Removing the CE marking

MELSEC-AnS series

FA-A-0278-A

For the A1S61PN

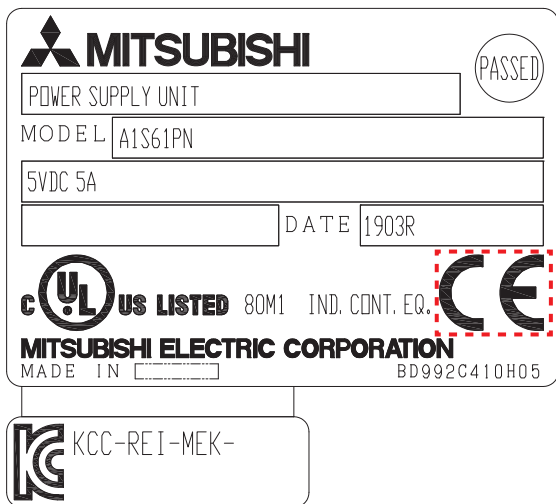
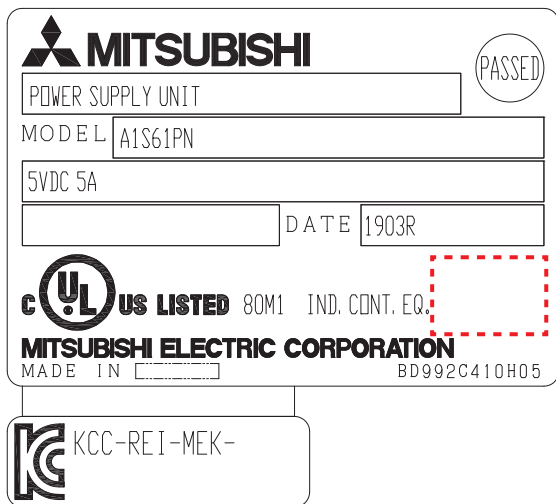
The CE marking is to be removed from rating plates and packaging labels.

Before change	After change
<ul style="list-style-type: none"> Rating plate 	<ul style="list-style-type: none"> Rating plate 
<ul style="list-style-type: none"> Packaging label 	<ul style="list-style-type: none"> Packaging label
